SITE PLAN

612 HIGHLAND DR. Austin, TX 78703

HR 21-039343 612 Highland

February 2021

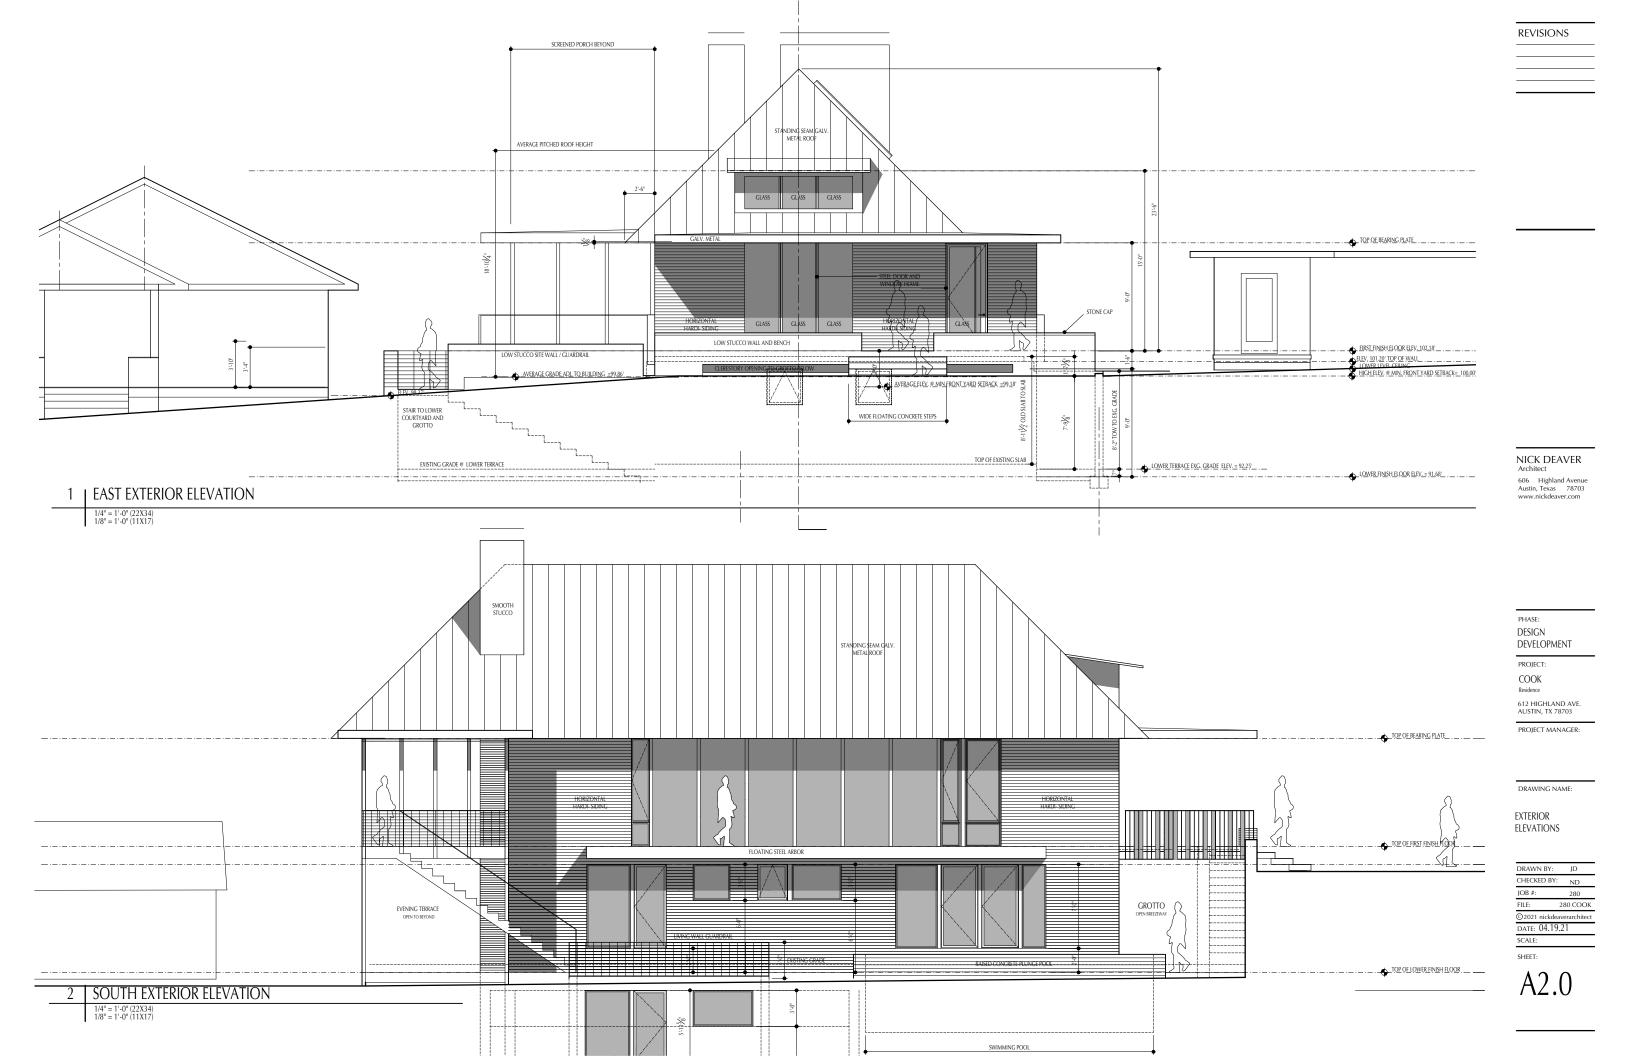
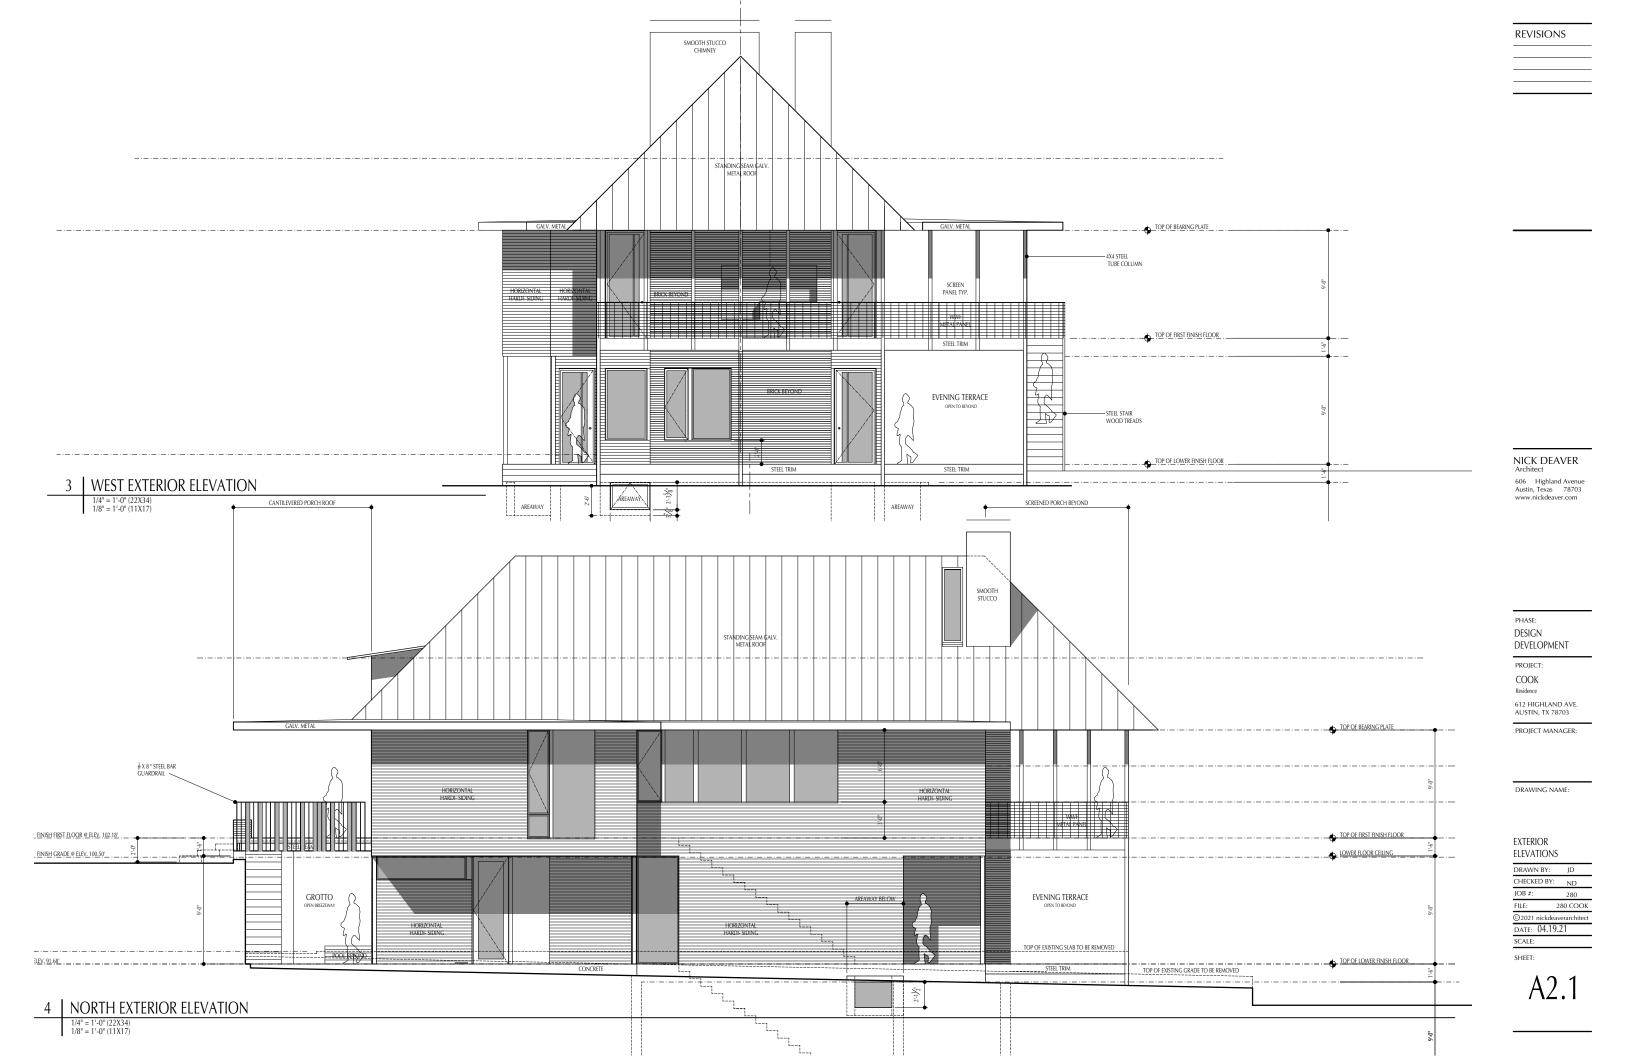
Changes based on ARC Comments 03/08/21

Changes based on Staff and HLC Comments 04/26/21

PORCH AND LANDSCAPE WALL-SEPARATED BRICK LANDSCAPING WALL BY 8" IN RESPONSE TO ARC COMMENTS

- CHANGED EXTERIOR STUCCO CLADDING ON WALLS TO HORIZONTAL SIDING
- CHANGED BRICK LANDSCAPE AND PORCH WALL TO STUCCO WITH A STONE CAP
- CHANGED METAL MESH PANEL PORCH END GUARDRAILS TO VERTICAL METAL RAILINGS INSPIRED BY CRAFTSMEN BUNGALOW RAILINGS
